**Pisolite Hills Project**

**Wenlock Basin Wild Rivers Submission**

**Cape Alumina Limited**

May 2009

Figure 3: Impact of the proposed HPA on the Pisolite Hills project. Pink area shows the JORC Code-compliant bauxite resource.

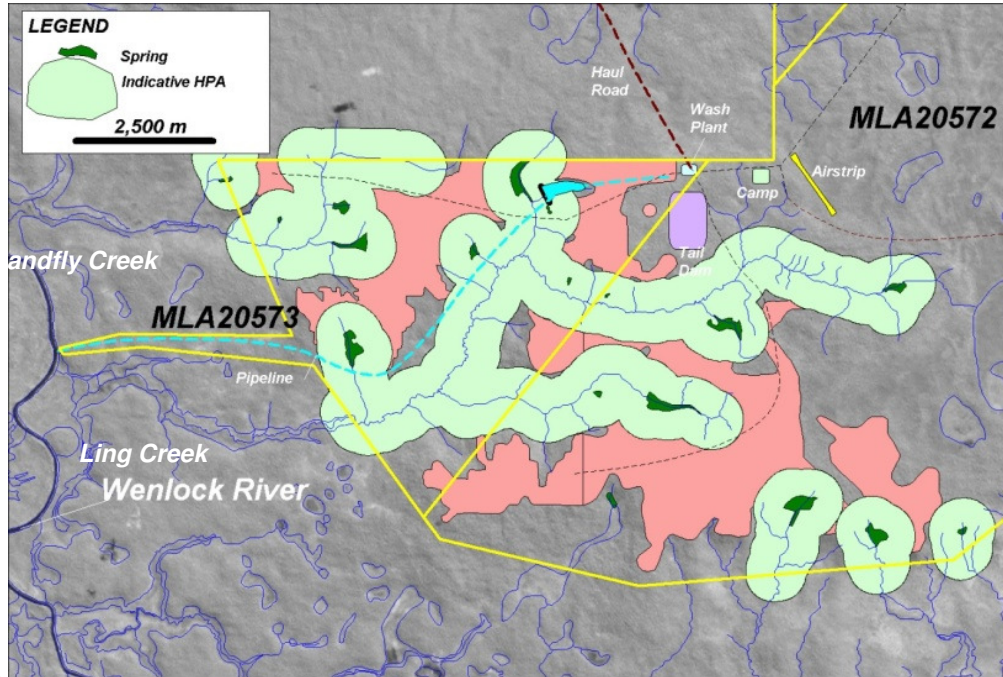
It is understood from the *Department of Natural Resources and Water (DNRW) guideline Wild Rivers Guide – Mining and Exploration* that surface mining activities are not permitted in a High Preservation Area. As indicated in Schedules 1 and 2 of the Wenlock Basin Wild River Declaration Proposal and in GIS layers provided by DNRW, the proposed High Preservation Areas of the Proposal will greatly restrict the activities proposed for the Pisolite Hills Project (Figure 3) and will have a significant detrimental impact on the project feasibility.

The effect of the Proposal as it currently stands will be to sterilise at least 15% of ML20572 and at least 58% of ML20573 which will result in the sterilisation of at least 28% of the JORC-code compliant Indicated Resource at Pisolite Hills. The estimated value of the bauxite which will be sterilised under the Proposal on the Cape Alumina Mining Leases alone is estimated to be approximately \$1 billion. Should the loss of this portion of the resource result in the project becoming unviable, the estimated lost revenue will approximate \$3-\$4 billion. In addition, hundreds of full time jobs will be lost.

Moreover, some environmental features in the vicinity of Pisolite Hills that we believe warrant protection are notably excluded by the proposed arbitrary buffers. For instance the evergreen spring shown in the lower middle section of Figure 3 to be outside the proposed arbitrary HPA, but covered by our recommended case by case HPA in Figure 7. We believe this highlights the inappropriateness of arbitrary HPA's, or buffer zones, in an area for which there is a large body of scientific data available.

Figure 6: Mapping errors in the definition of Special Features

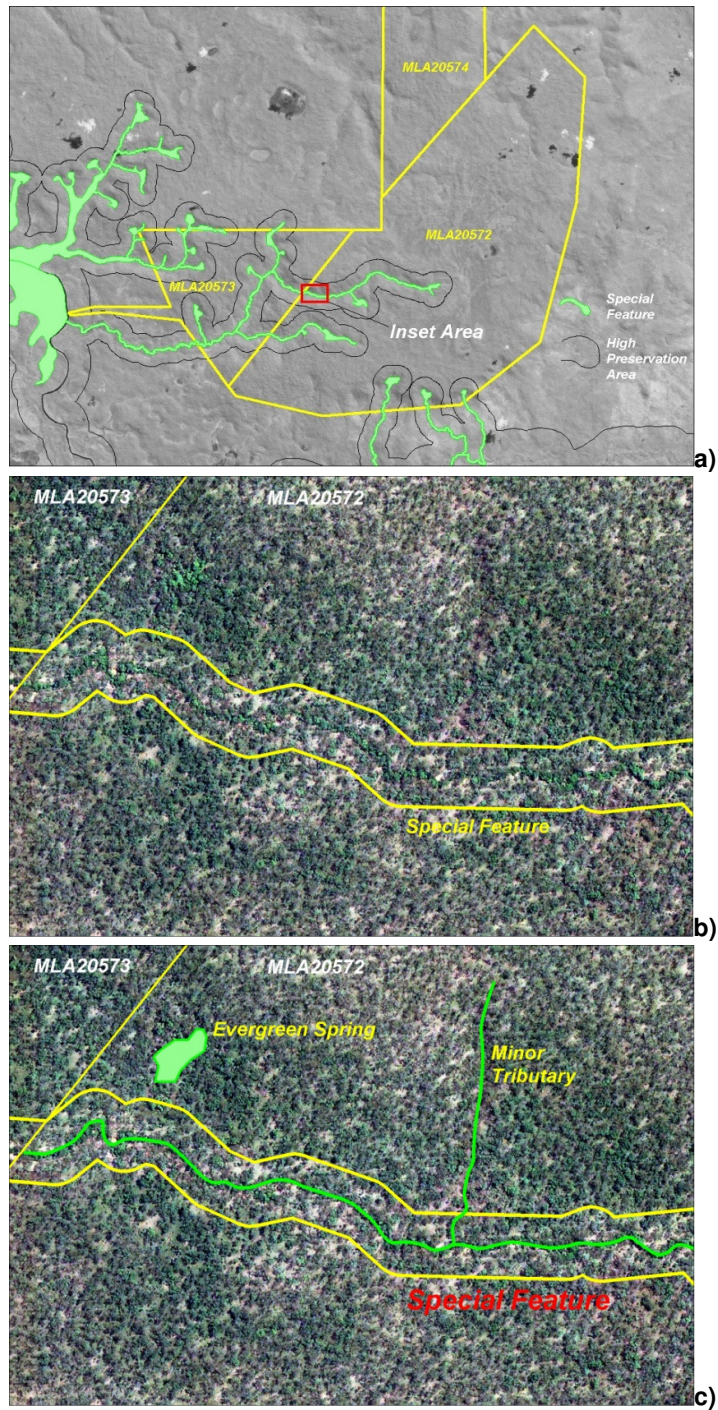
The High Preservation Area (HPA) setback zones associated with Ling Creek, Sandfly Creek, and the Special Features in the vicinity of Pisolite Hills are provided in the Declaration Proposal (as shown in Figure 1 and 3). Mapping of the GIS layers supplied by DNRW shows that buffers extending 500m either side of all Special Features are proposed to be designated as High Preservation Areas. However, no documentation supplied by DNRW contains an explanation or justification for the determination of the extent of these buffer zones, and there is no reference given to published literature or accepted practices for environmental buffers. It must therefore be concluded that the proposal is simply an arbitrary determination, with lines drawn on a map without the benefit or consideration of actual site-specific scientific data on the ecology or hydrology of the site.

Furthermore, it can be shown from the GIS data derived from the Overview Report, that the Special Features in the vicinity of Pisolite Hills are in fact **buffers** around the environmental features rather than the mapped outlines of the environmental features themselves. Figure 6 illustrates the errors in mapping of the Special Features in the vicinity of Pisolite Hills (Figure 6a) as shown in the overview report. Figure 6b) is a close-up of the Special Feature which is a tributary of Ling Creek. The yellow lines are 100m apart and represent a 50m buffer either side of the creek line. In Figure 6c) the actual riparian zone around the tributary is highlighted. This riparian zone has an average width of between 5 and 10 metres. In addition, the "Special Feature" as mapped in the Overview Report excludes both a tributary and an evergreen spring, but includes a wide zone of open dry Stringybark woodland unrelated to the tributary or its riparian zone.

Similarly, mapping of those springs defined as Special Features includes buffers extending up to 85m out from the wet edge of the springs. It is from the edge of these buffers that the HPA starts (Figure 6a).

The result of these proposed buffers upon buffers means that the actual HPA as proposed at Pisolite Hills are a minimum of 1120m wide. This means that the declaration proposal as it currently stands is to establish HPA over buffers extending up to 112 times the size of the actual environmental feature being protected. This is far in excess of any recommended buffers based on any scientific publication and is against the recommendations of independent ecologists.

There is no logic in the application of a buffer on a buffer and this approach will result in the unnecessary sterilisation of JORC Code-compliant ore resources at Pisolite Hills and threaten the viability of the project without any basis in environmental science.

The tributaries in the vicinity of Pisolite Hills are very narrow and Cape Alumina recommends that mapping of the Special Features be restricted to the features themselves which, in the case of the tributaries, have a total width of between 5 and 15m in the immediate vicinity of Pisolite Hills. In the case of the springs, Cape Alumina recommends those feature be mapped to the wet edge.

Figure 7: Recommended HPA in the Pisolite Hills area based on a scientific appraisal of the environmental features.

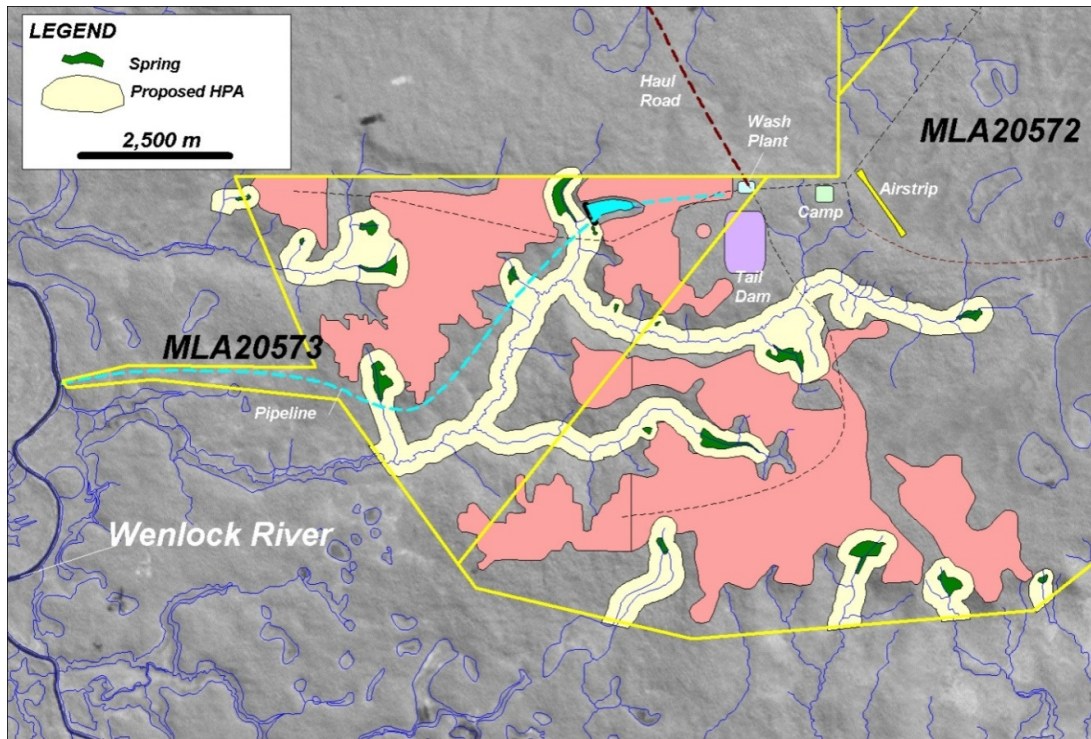
To address the functions outlined above, in keeping with the recommended buffer widths described in the published literature (Section 5.1) it is recommended that the following buffer widths are applied in the Coolibah Springs Complex:

- Small evergreen springs – 100m
- Medium evergreen springs – 150m
- Large evergreen springs – 200m

HPAs following this recommendation in the vicinity of Pisolite Hills (including on the adjacent Alcan Mining Lease ML7031) will ensure that both the springs themselves, their resulting watercourses and the surrounding vegetation are fully protected as High Preservation Areas whilst allowing for reasonable and carefully managed development of valuable and strategic mineral resources in the so called "Preservation Area".

Figure 7 shows the proposed mine-related infrastructure in relation to the recommended HPA at Pisolite Hills. A raw water pipeline and mine haul roads are planned to cross the HPA's as recommended by Cape Alumina. These features are "*specified works*" under the Act and therefore we anticipate there will be no restriction to their proposed development pursuant to any declaration under the Act. In addition, Cape Alumina plans to draw water from the tidal zone of the Wenlock River at the western end of MLA20573.

**Figure 10: Pisolite Hills area - evergreen springs, tributaries and HPA based on a) scientific assessment as proposed by Cape Alumina, and b) arbitrary HPA as proposed in the Overview Report.**

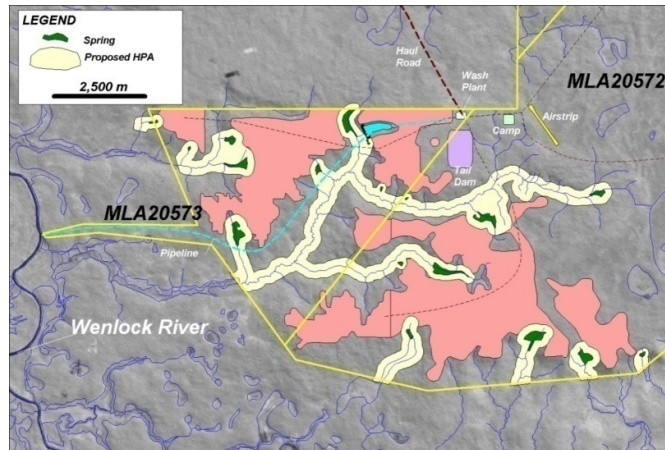
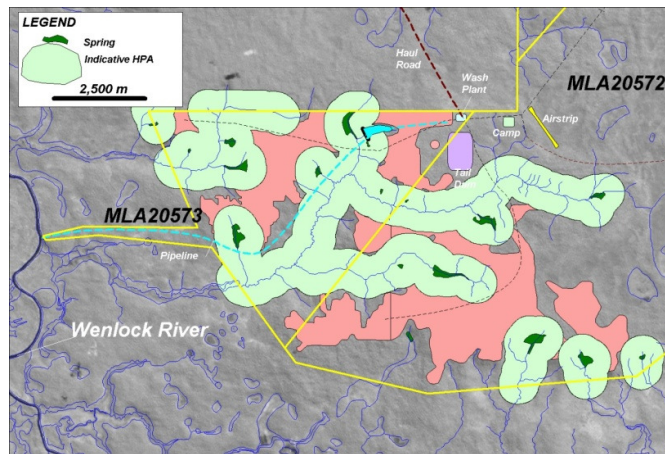
Figure 10 shows the distribution of ore resources and the actual mapped extents of the “Special Features” at Pisolite Hills. In Figure 10a) HPA as recommended in this submission and based on a rigorous scientific analysis are shown, whereas Figure 10b) illustrates the impact of the arbitrary HPA, as proposed in the Overview Report, on the mineral resources at Pisolite Hills.

Tables 4 and 5 list the impact of the two alternative HPA zones at Pisolite Hills on the current JORC code-compliant mineral resources. These tables show that the HPA as recommended by Cape Alumina in this submission will have a small impact on the mineral resource at Pisolite Hills by sterilising 2% of the total resource. In contrast, Table 5 shows that the HPA as proposed in the Overview Report will sterilise at least 28% of the mineral resources at Pisolite Hills.
